## **ADDENDUM #5 :**

**Rehabilitation of the sewers,  
the watermain and the  
parking lot of the workshop  
and rehabilitation of the 15,5  
site of the Lachine Canal**

**Addendum no 5**

**Project Number: CLAC-1803**

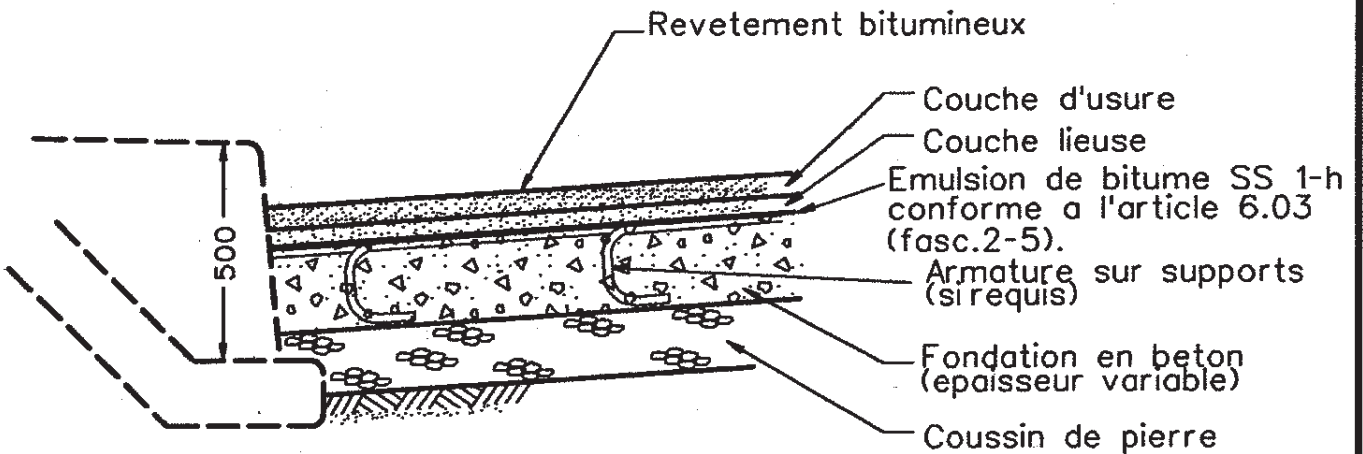
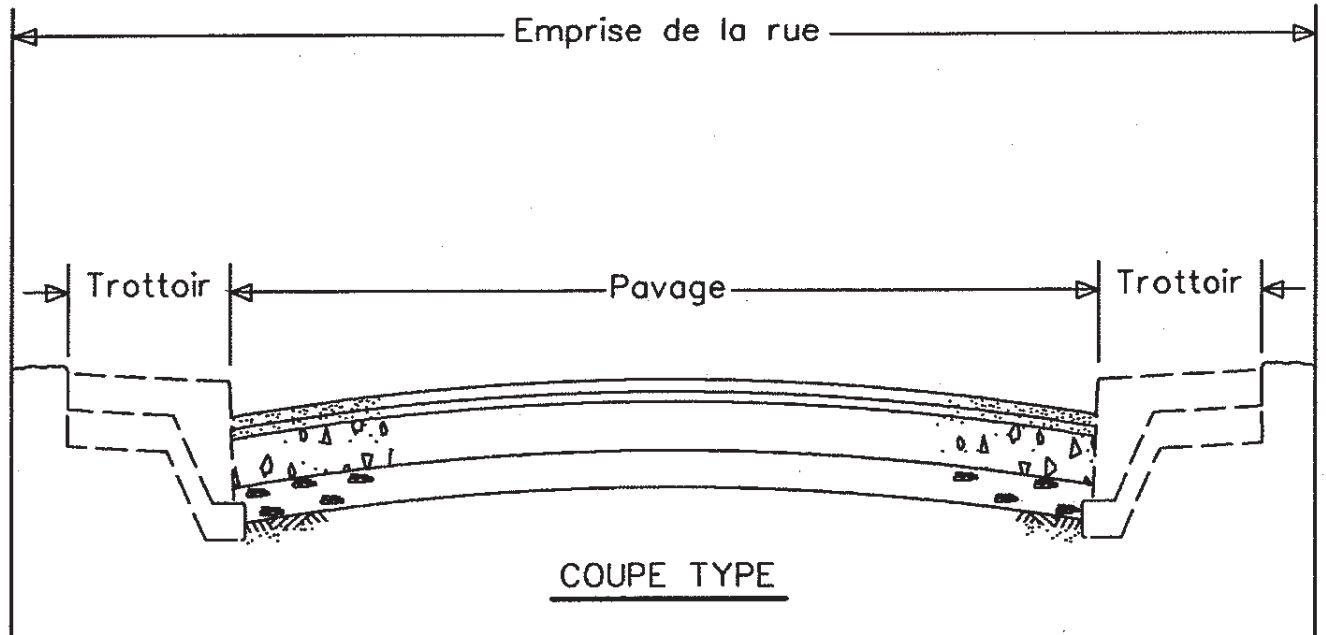
1.7.4	Supply and installation of TBA Class IV storm sewer pipe, 375 mm diameter	36	LM	\$	\$
1.7.5	Supply and installation of TBA Class IV storm sewer pipe, 525 mm diameter	22	LM	\$	\$
02 1.7.6	Supply and installation of storm sewer pipe, 750 mm diameter <del>HDPE pipes with smooth inside and outside walls</del> <b>plastic materials pipes</b> with a minimum stiffness of 320 kPa according to the BNQ 1809-300 standard	10	LM	\$	\$

Item	Description	Quantity	Unit	Unit Price	Amount
1.7.8	Supply and installation of a retention basin, pipes 1200 mm diameter, <b>including the drawings signed and sealed by an Engineer</b>  <del>HDPE Plastic materials pipes (HDPE, polypropylene, FRP, ...) with a minimum stiffness of 320 kPa with smooth inside and outside walls with a minimum stiffness of 250 kPa according to the ASTM F894 standard, including the access chimneys</del>	1	global	_____ \$	_____ \$
